CM-25 MINE PERMIT AMENDMENT
APPLICATION PERMIT No. M-1977-307
Response to Adequacy Review #4

April 2013

CM-25 Mine, File No. M-1977-307, Amendment (AM1) Application Adequacy Review (4)

SECTION F-F

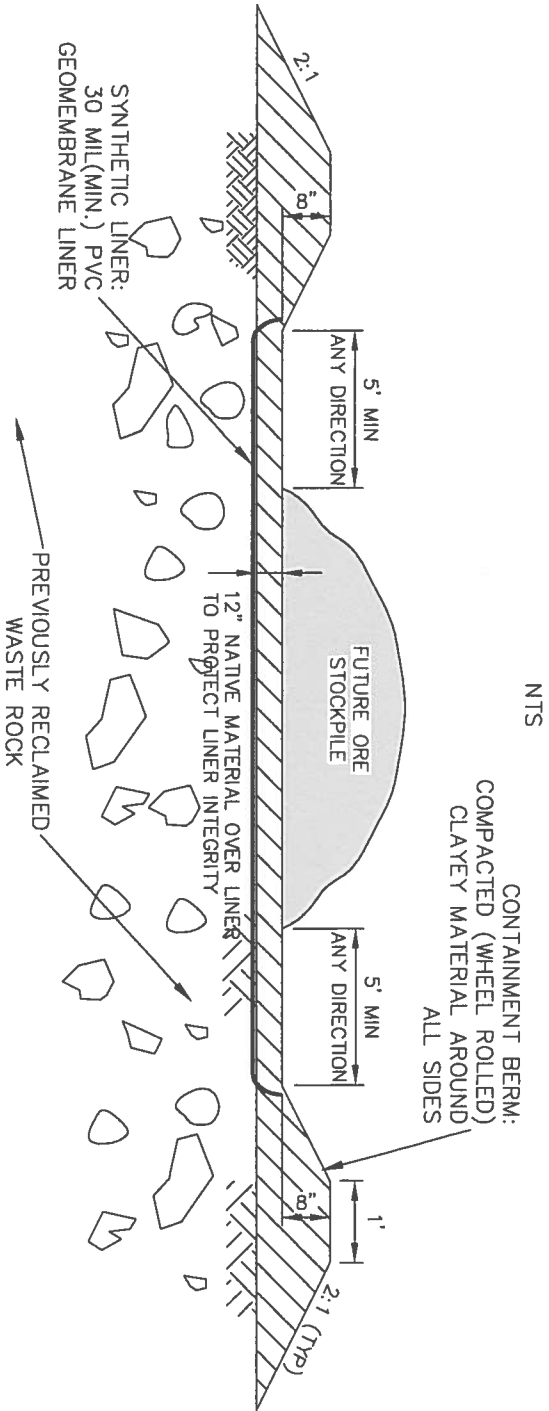
1. Page 1, Response 1a - "possible liner". The DRMS agrees this area should have a liner to collect potential leachate and prevent it from entering the underlying waste rock. Based on the drawing provided in Attachment 2, the DRMS has four concerns in addition to the unaddressed compaction and permeability specifications requested in the original

Comment 1a:

- a. A six-inch liner is insufficient. The DRMS requires a minimum clay liner thickness of 12 inches.*
- b. In order for the leachate collection system to function properly, it needs to be drained by gravity and have a lined collection pond or receptacle. Please provide drawings to indicate the expected drainage system slope and a collection pond/receptacle to separate collected leachate from the environment.*
- c. Please explain how the clay liner will be protected from desiccation cracking that could cause the liner to leak.*
- d. The liner needs a leak detection system to ensure the leachate collection system is functioning properly. Please provide a description and drawings for a leak detection system.*
- e. Please provide the originally requested compaction and permeability specifications for the clay liner.*

A new liner for the ore pad is proposed in the revised drawings included with these responses to address the original concern of possible leachate entering the waste rock pile under the pad. Attachment 1 is a schematic of the proposed ore pad liner. It consists of a 30 mil (min.) pvc geomembrane liner covered with twelve inches of native soil to provide integrity protection. Local soils that have a high clay content will be preferentially selected to

provide an additional level of protection. This type of liner should eliminate concerns regarding compaction requirements and potential cracking of a clay liner.

In response to the comment regarding a leachate collection system, the geomembrane liner and cover material should contain all potential run-off from the ore pad area. The limited time that ore is exposed on the contained ore pad should not result in significant leachate, and any precipitation falling in the ore pad area should evaporate as a result of the extremely arid environment prior to any potential leachate escaping to the environment.

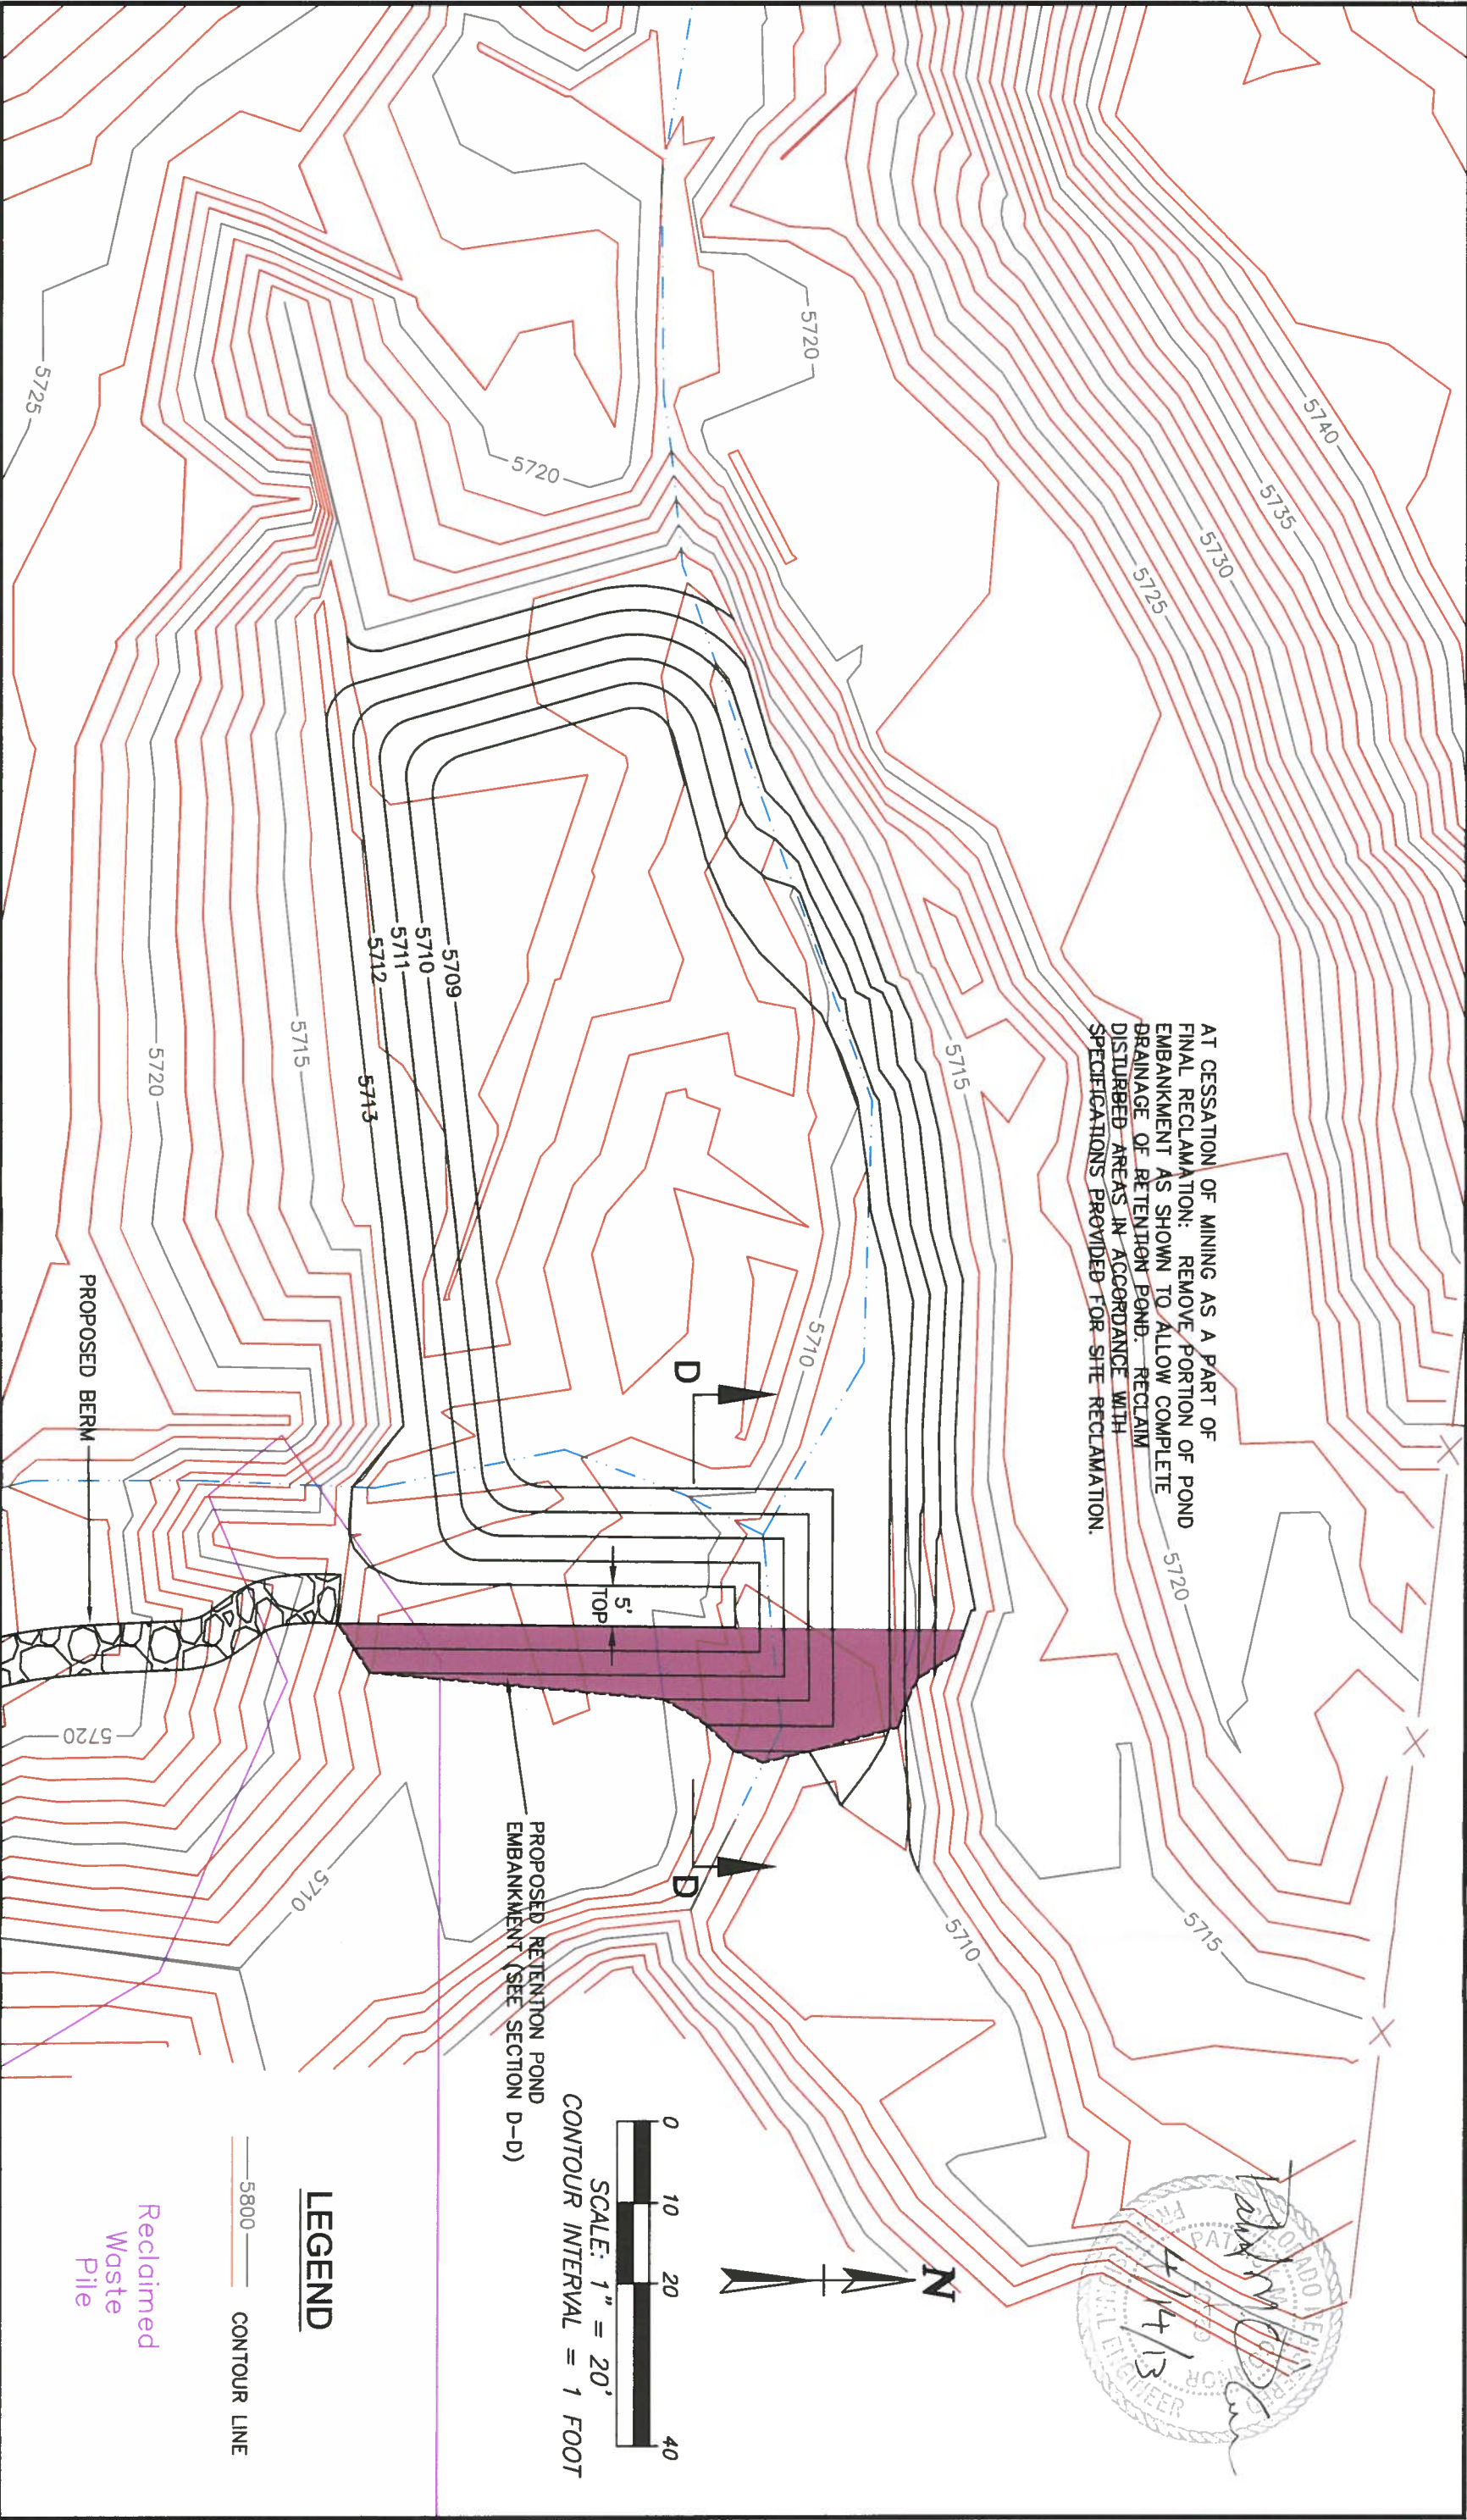
2. *Page 6, Response 5 — pond reclamation. Stormwater ponds require maintenance to prevent embankment breaching and/or headcutting which leads to long-term erosion problems. In addition, the Division of Water Resources may require the release of stormwater within 72 hours if there is a call on the river. As such the DRMS requires the retention pond to be reclaimed so that stormwater is not retained unless the land owner*

intends to use and maintain the pond after mine reclamation. Please provide revised reclamation plans for the pond or documentation demonstrating the land owner intends to maintain the structure.

Revised drawings are included in Attachment 2 (sheet 5a of 6) to illustrate the ultimate removal and reclamation of a portion of the pond embankment to the level of the pond bottom, which will allow flows to pass through the system after cessation of mining activities and reduce long-term erosion potential. A low-water drain is also included for release of detained water from the pond bottom during normal operation, as requested. This drain is illustrated in portions of Attachment 3 (sheets 4 and 5 of 6).
